PRODUCT/PROCESS CHANGE NOTICE (PCN)

PCN #: **TB1912-02(R1)** DATE **June 9, 2020**
 Product Affected: **3mm X 3mm VFQFN**
4mm X 4mm VFQFN
 (Refer to attachment for affected part#)
 Date Effective: **June 9, 2020**

Revision 1: This revised notice is to retract the changes as stated in the original PCN# TB1912-02 issued in December 20, 2019 after taking customers' input into consideration. With this, changes as stated in the original PCN will not be implemented.

Future Shipment in Cut Tape Packing for MSL 1 Product

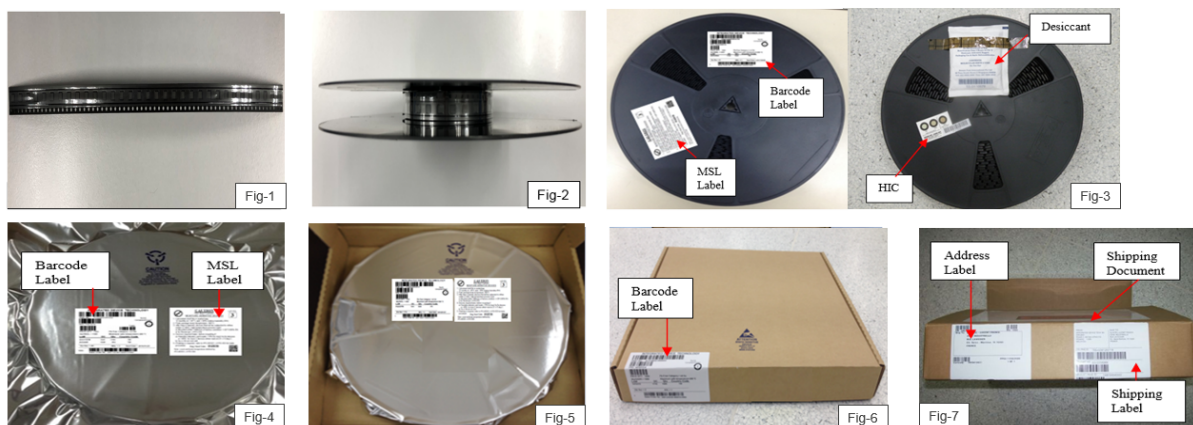
- Count and cut the parts in carrier tape as per order qty (Fig-1).
Note: Without Leader & Trailer empty pockets.
- Roll the part onto plastic reel and tape with conductive tape at both end (Fig-2 & 3).
**** Note :** Pass IDT Standard 6 fts drop test (Base on drop test result with NLG 16 (QFN 3x3 mm) and NLG 24 (QFN 4x4 mm))
- Pack with Shielding bag (Fig-4).
- Pack with pizza box (Fig-5).
- Over-pack the pizza box with Outer carton (Fig-6).

- Count and cut the parts in carrier tape as per order qty (Fig-1).
Note: Without Leader & Trailer empty pockets.
- Roll the part onto plastic reel and tape with conductive tape at both end (Fig-2 & 3).
**** Note :** Pass IDT Standard 6 fts drop test (Base on drop test result with NLG 16 (QFN 3x3 mm) and NLG 24 (QFN 4x4 mm))
- Pack with HIC & Desiccant
- Pack with MBB bag (Fig-4).
- Pack with pizza box (Fig-5&6).
- Over-pack the pizza box with Outer carton (Fig-7).
